PSC Reclamation Division Memorandum

Memorandum

Date: September 30, 2022

Subject: MLJ response to “Comments of Casey and Julie Voigt, Objection to Mine Plan, and Request for Informal Hearing

Figure 1: GPS point tracklog of the inspection route (black) and the permit area (orange).

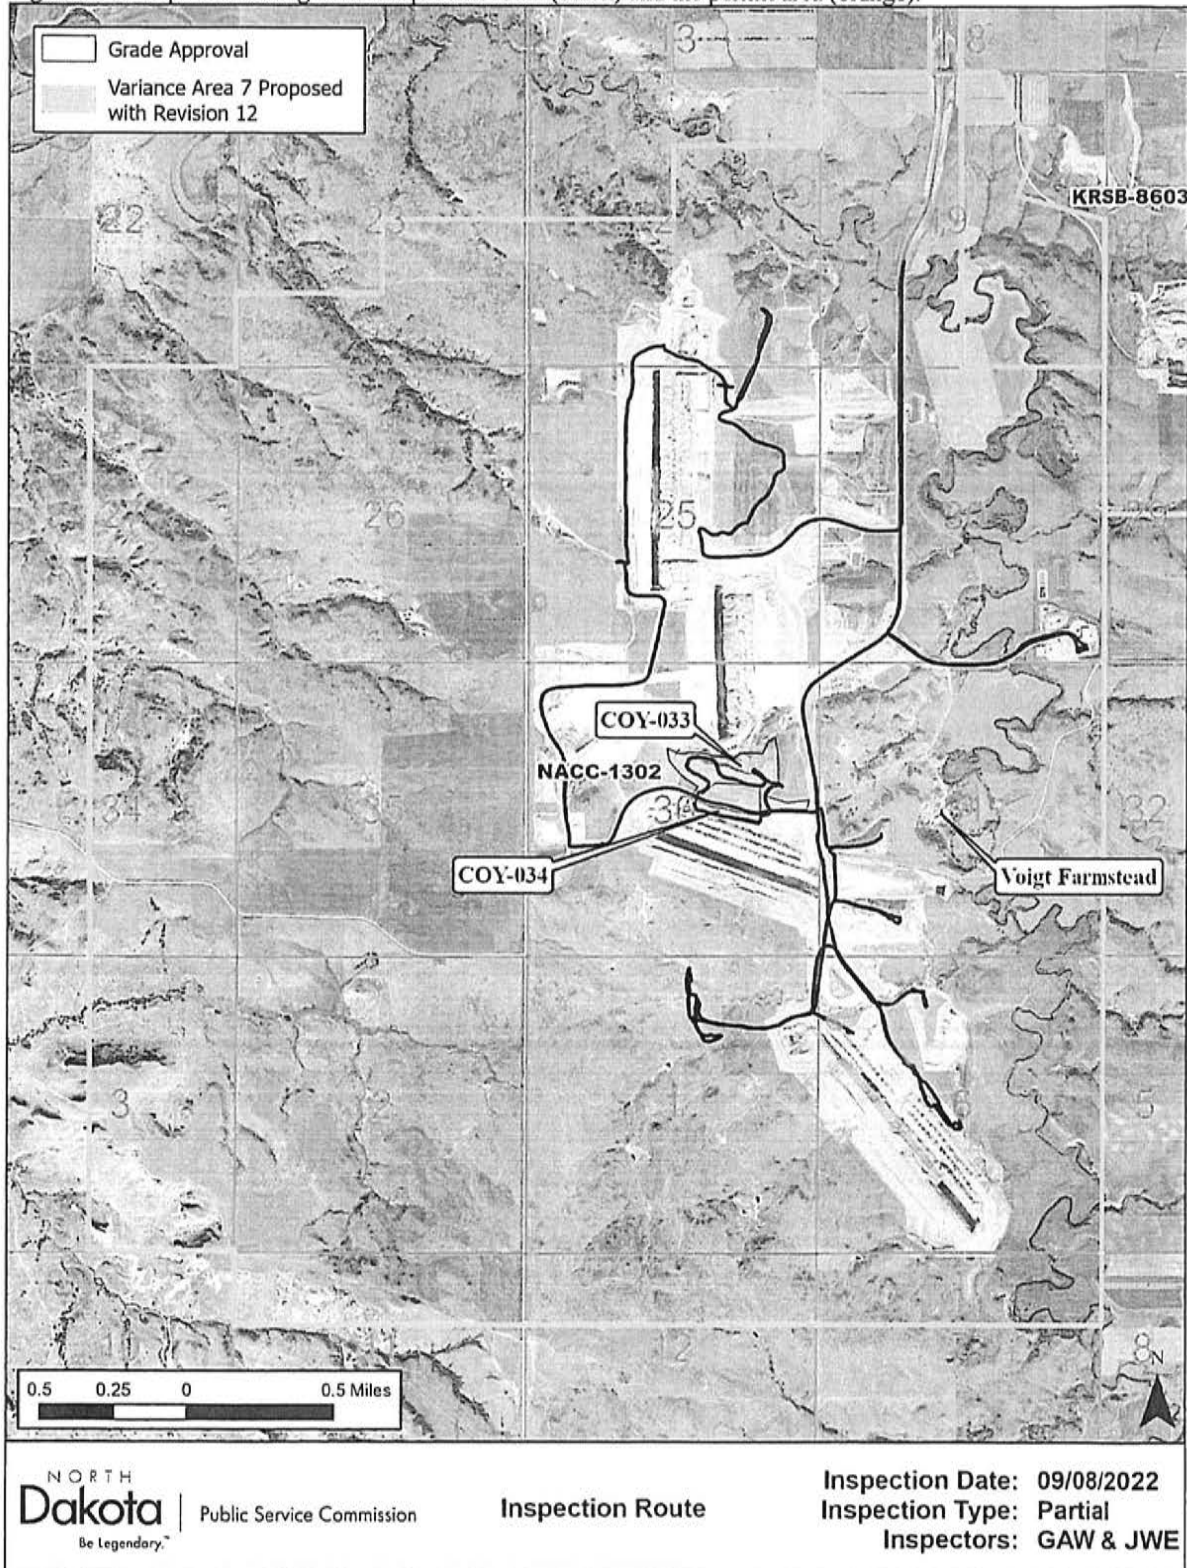
Backfilling and grading appeared contemporaneous or in compliance with plans approved in the permit. The area associated with proposed Variance Area No. 7 with Revision No. 12 was inspected. This area is located primarily in the NW¼ of Section 6. Most of the coal was removed from this area in 2019 with a small portion of coal removed in 2020. This variance area has been rough graded except for a spoil peak or pile immediately south of sediment pond P06-03. The surface of the spoil on this proposed variance area appears to consist of heavy clay soil that is very hard when dried and it does not appear that this spoil

Grade approval requests COY-033 and COY-034 in Section 36 of Permit NACC-1302 were inspected. The topography or surface contours of both areas conform to the topography approved in the permit and the surface is generally smooth and ready for subsoil respread. Mr. Sailer was reminded that steep slopes must be scarified prior to subsoil respread to reduce the potential for soil slippage. Mr. Sailer indicated that CCMC was planning to respread grade approval COY-033 beginning at the lowest elevation and moving upslope to reduce compaction.

Portions of grade approval requests for COY-033 and COY-034 include land along the quarter line between the NE $\frac{1}{4}$ and SE $\frac{1}{4}$ of Section 36. The approved post-mining land use map indicates that a permanent access road is to be constructed on this quarter line. CCMC staff verbally indicated that the Mine, Mercer County, and Mr. Casey Voigt are in the process of revising the agreement regarding the location of this access road. Reclamation Division staff indicated that CCMC may need to provide a written account of the changes planned regarding this road prior to grade approval. This issue should also be addressed in each grade approval request to explain why a road is not shown on these grade approval requests.
